4 April 2023

RE: BGYF2 17-21 Kimberley Street, Merrylands, NSW
SEPP Housing 2021 clause 93

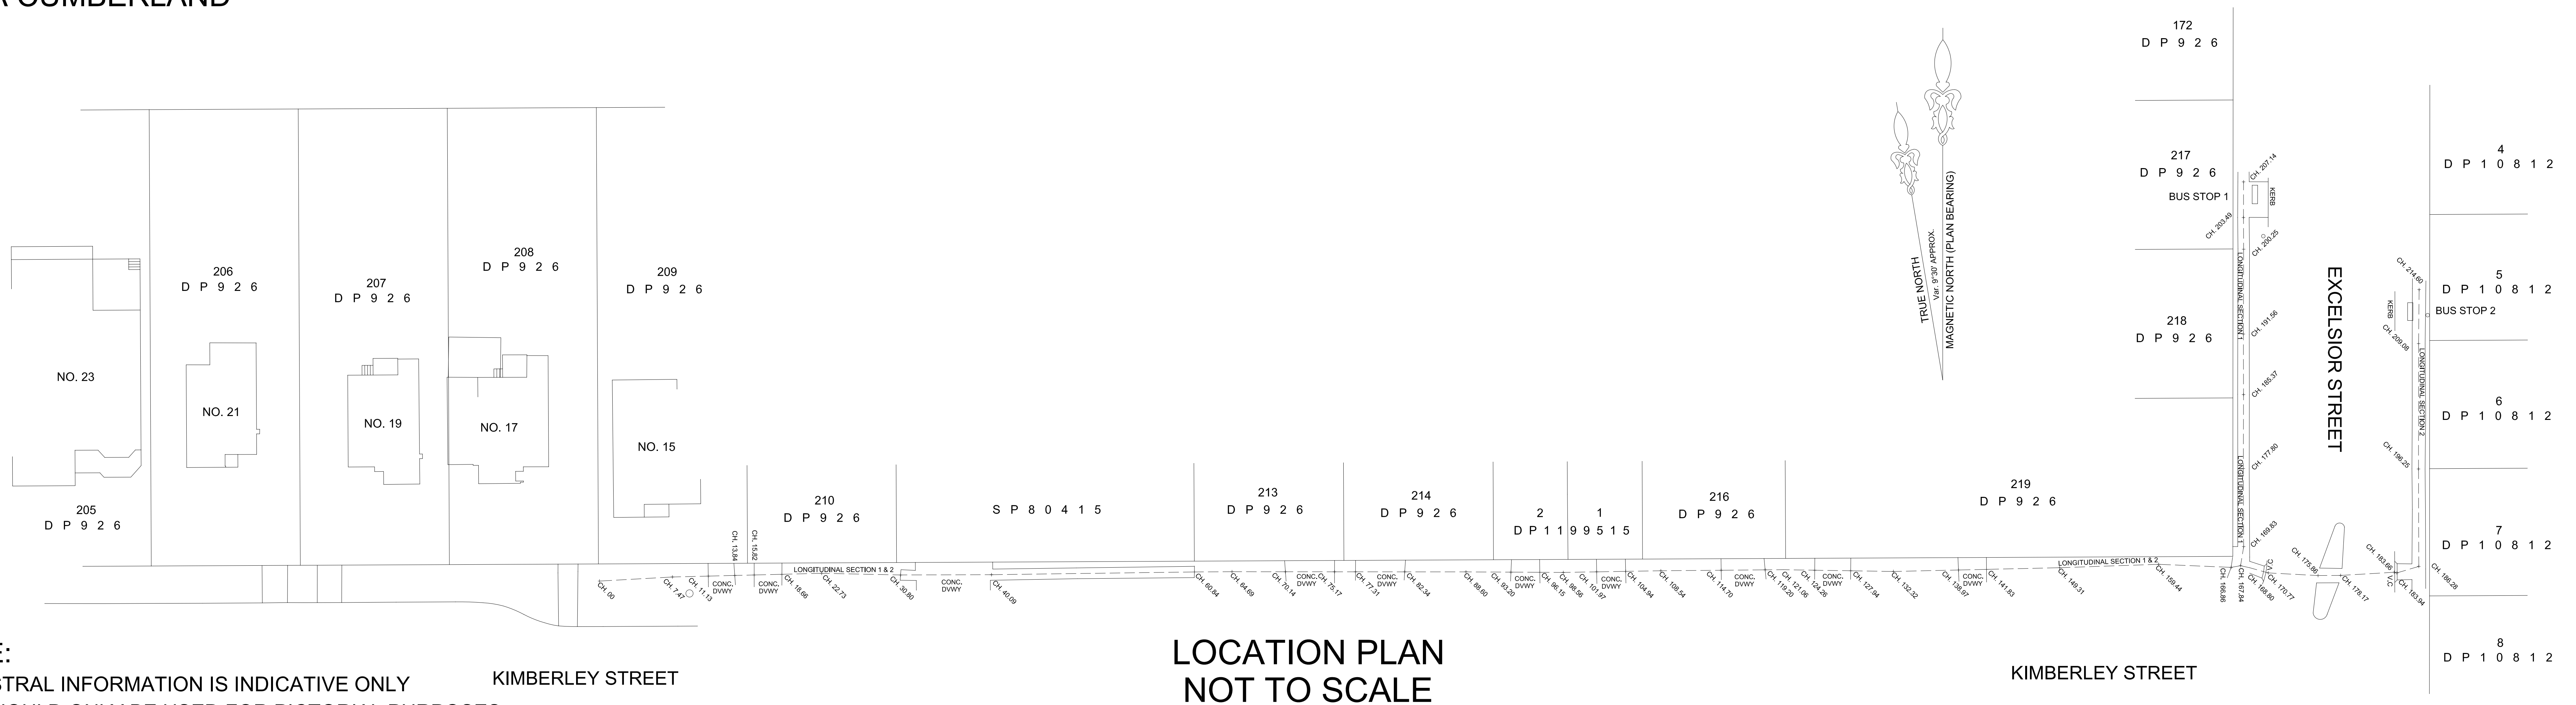
We have reviewed the longitudinal sections provided for Excelsior St against the requirements of the Housing SEPP as below:

- The overall average gradient is
 - Route 1: approx. 1:84
 - Route 2: approx. 1:67
- The 15m length gradients remain under 1:12 for both routes
- The 5m length gradients remain under 1:10 for both routes
- The 1.5m length gradient remains under 1:8 for Route 1 (Longitudinal Section 1)
- The 1.5m length gradient does not remain under 1:8 for Route 2 (Longitudinal Section 2) – at the location highlighted below, and this will need to be evaluated on site and corrected, if necessary, as part of the works. A new kerb ramp would need to meet the relevant Australian Standards including AS1428.1 and Council engineering standards.
